Falcon Highlands Filing No. 3

Master Development Drainage Plan

March 18, 2022

SKP-21-004

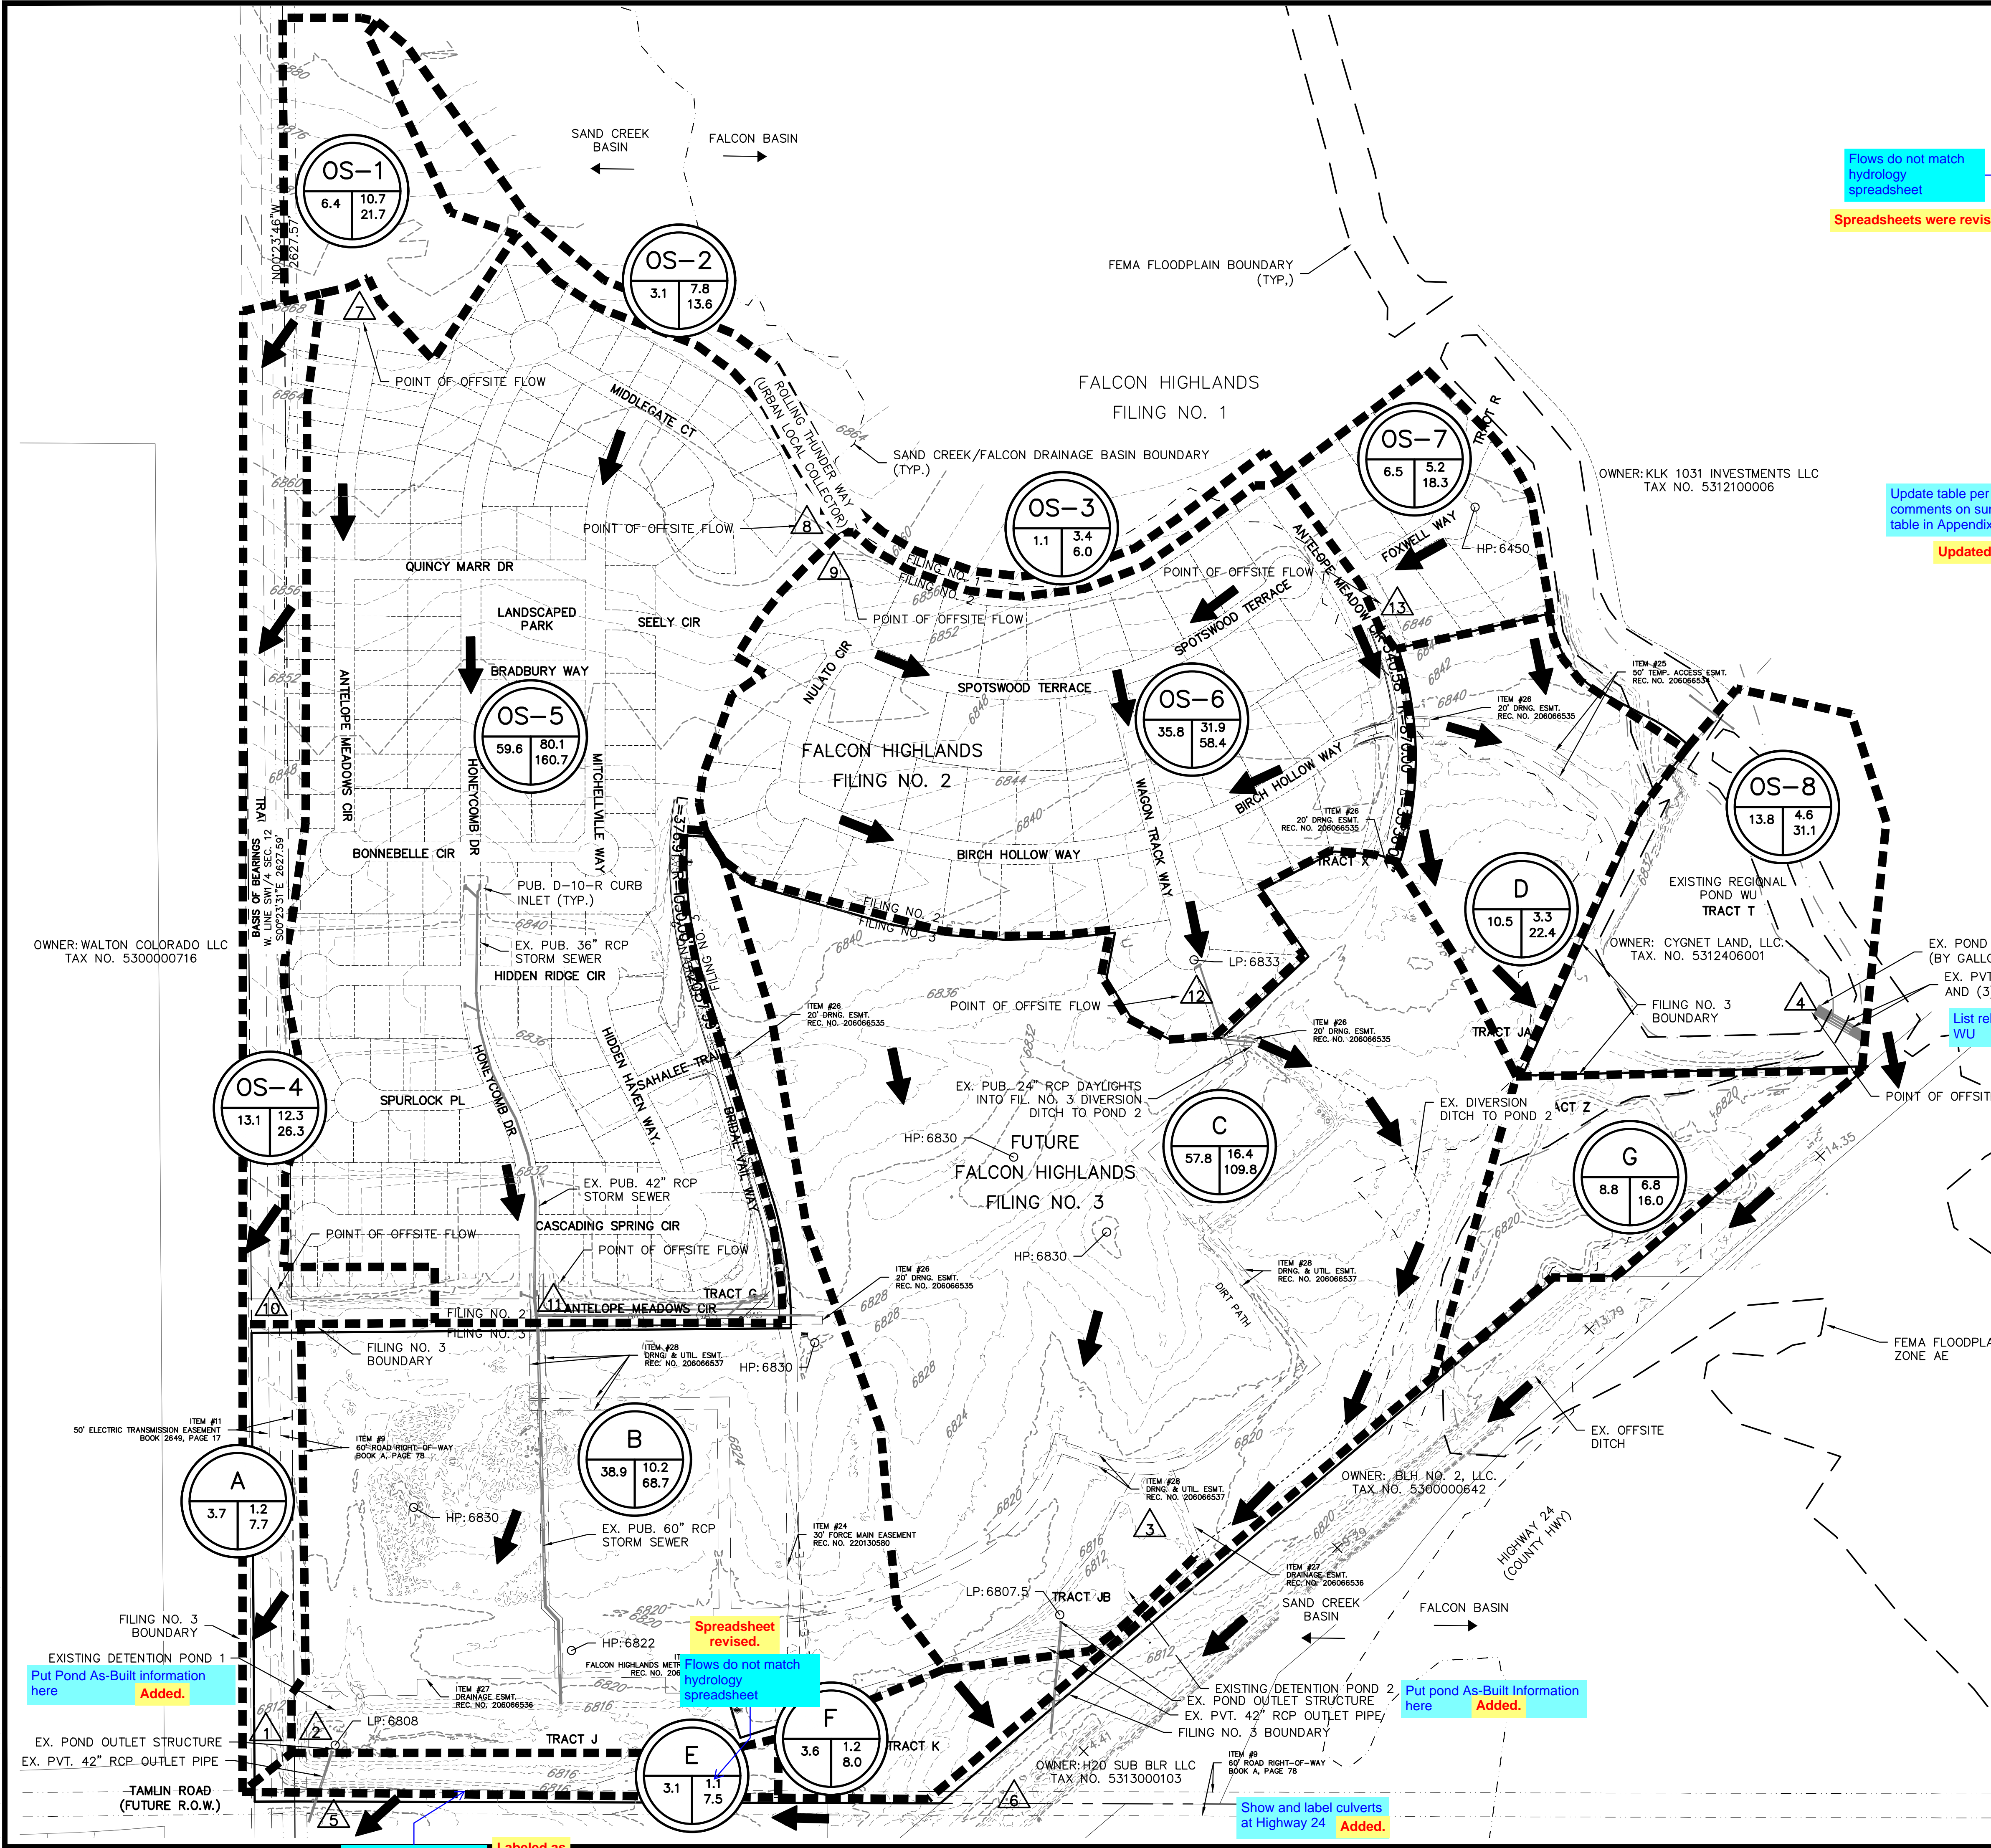
ROW line does not match plan

List release rates from Pond WU

Updated.

Updated.

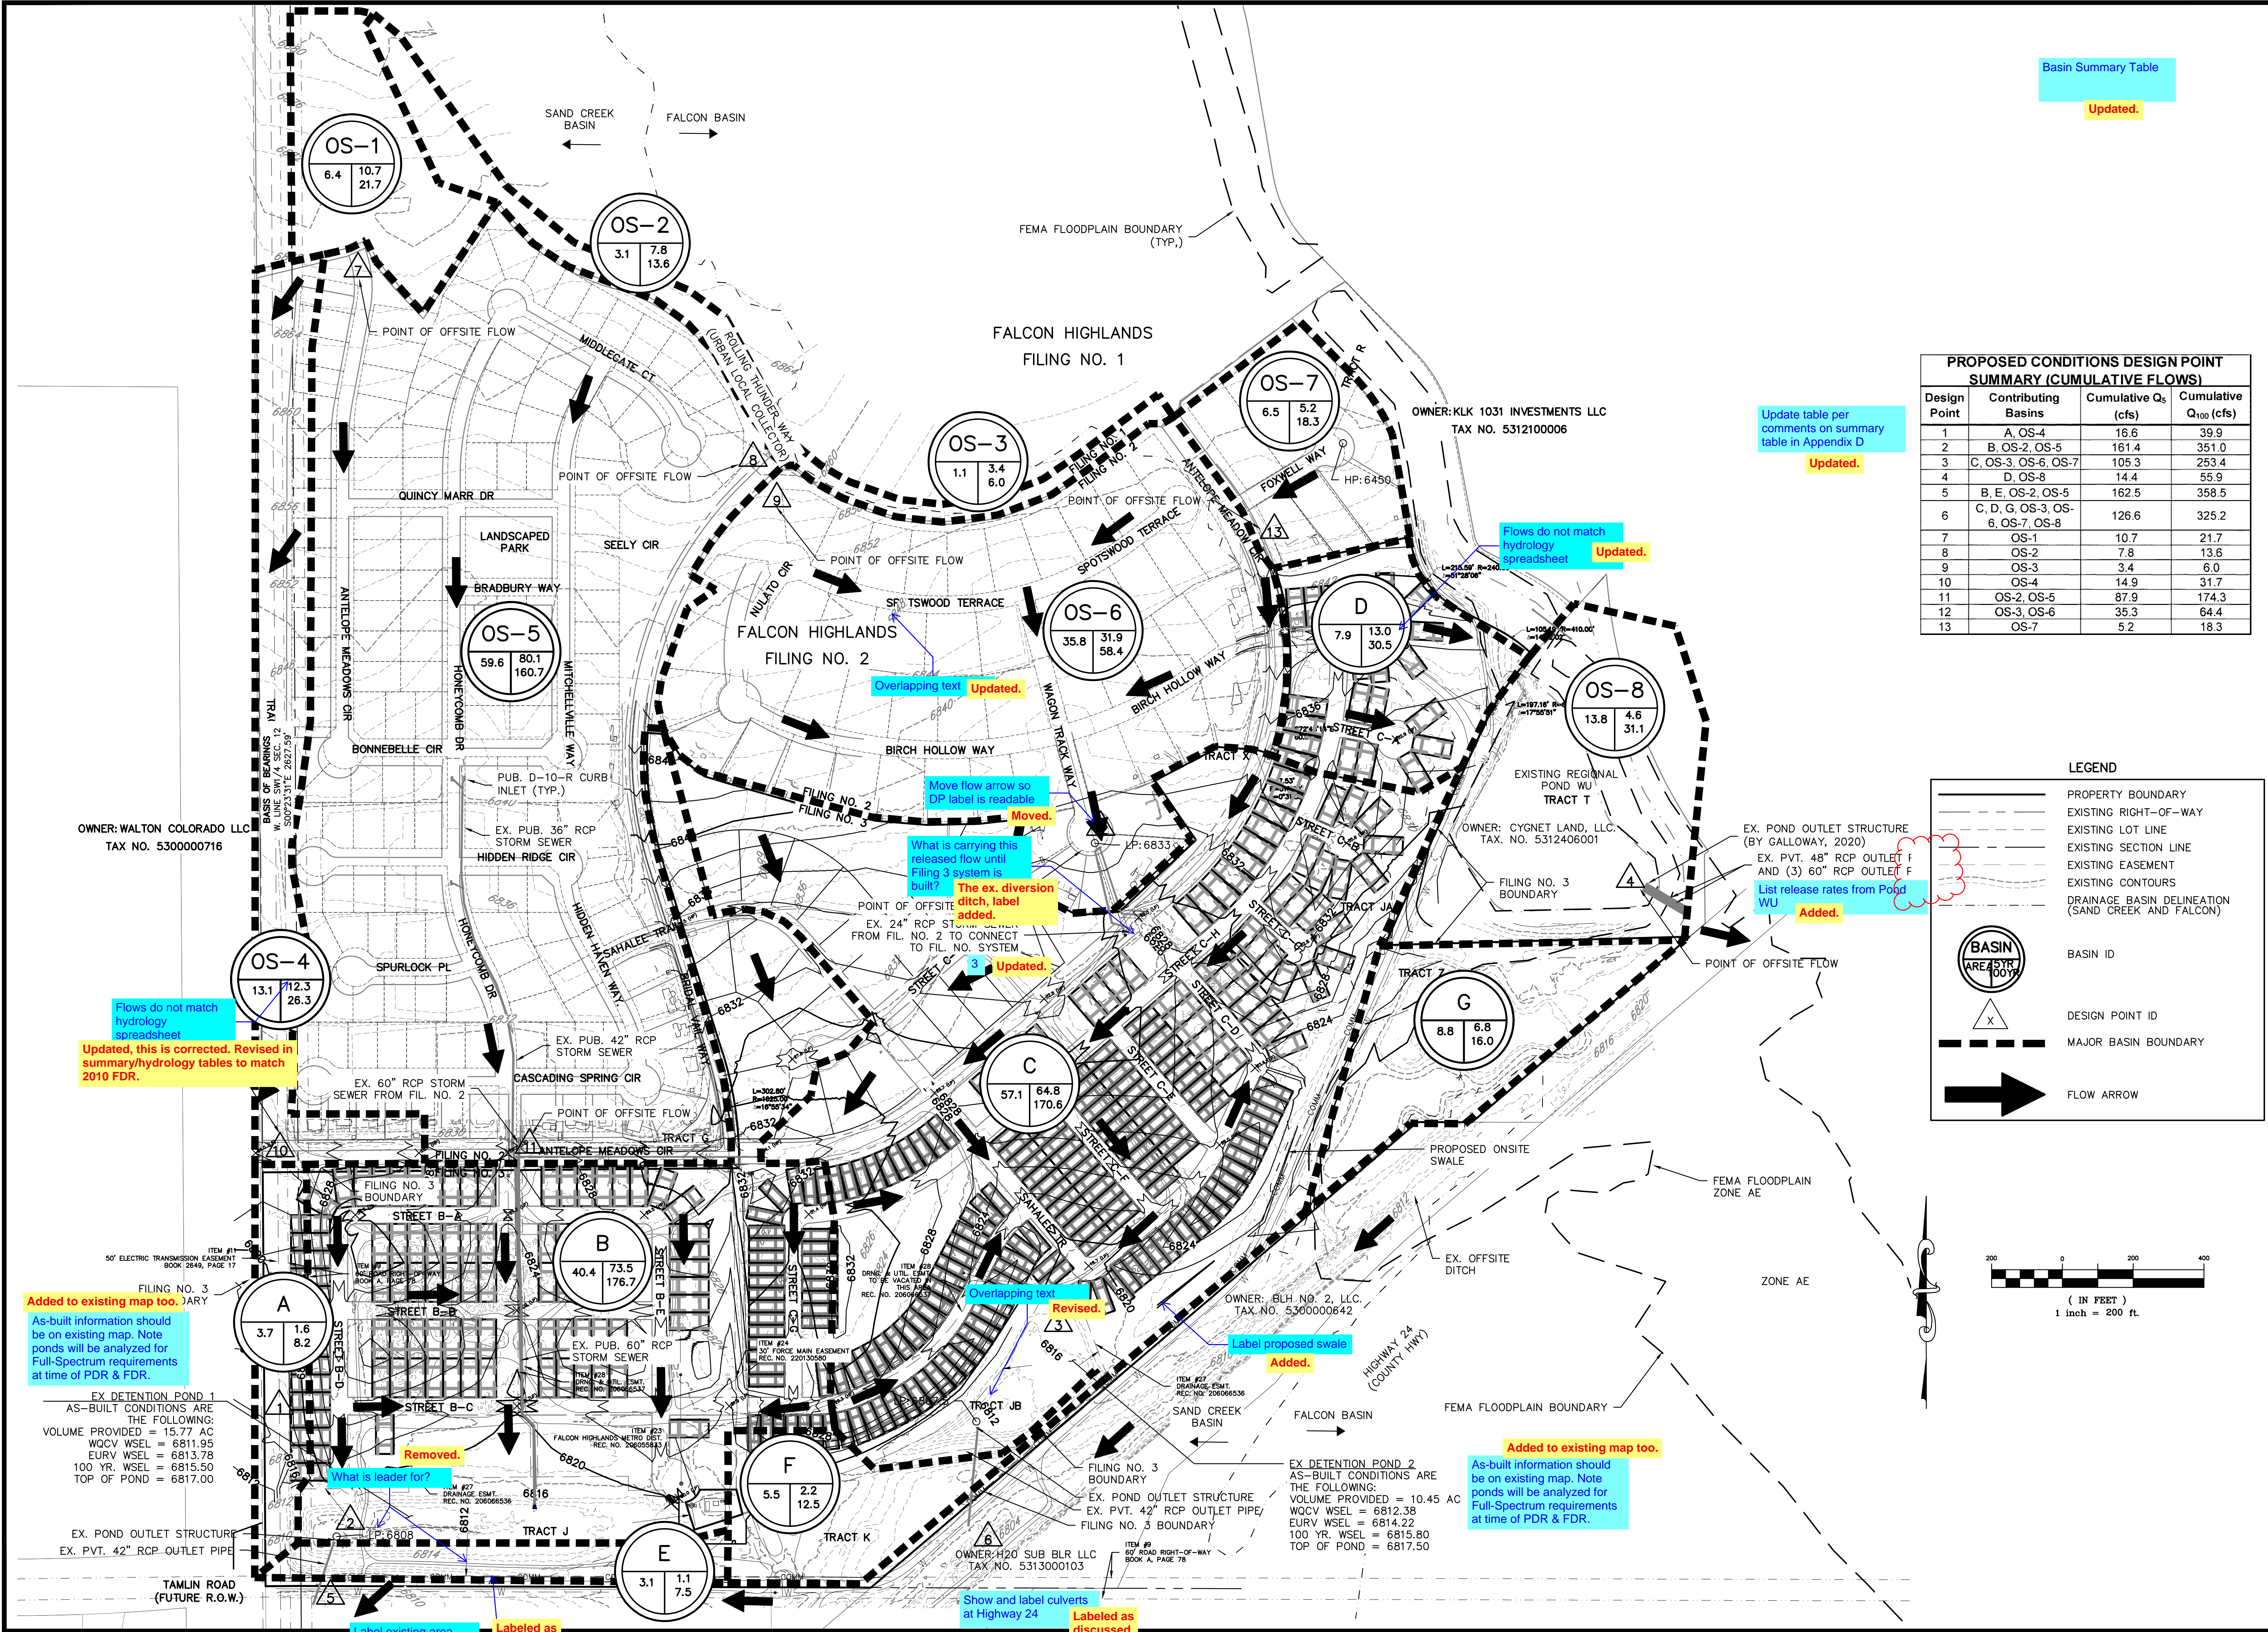
Flows do not match hydrology spreadsheet
Updated.

What is carrying this released flow until Filing 3 system is built?
The ex. diversion ditch, label added.
Updated.

List release rates from Pond WU
Added.

Flows do not match hydrology spreadsheet
Updated, this is corrected. Revised in summary/hydrology tables to match 2010 FDR.

As-built information should be on existing map. Note ponds will be analyzed for Full-Spectrum requirements at time of PDR & FDR.
Added to existing map too.

Show and label culverts at Highway 24
Labeled as discussed.

As-built information should be on existing map. Note ponds will be analyzed for Full-Spectrum requirements at time of PDR & FDR.
Added to existing map too.

Label proposed swale
Added.
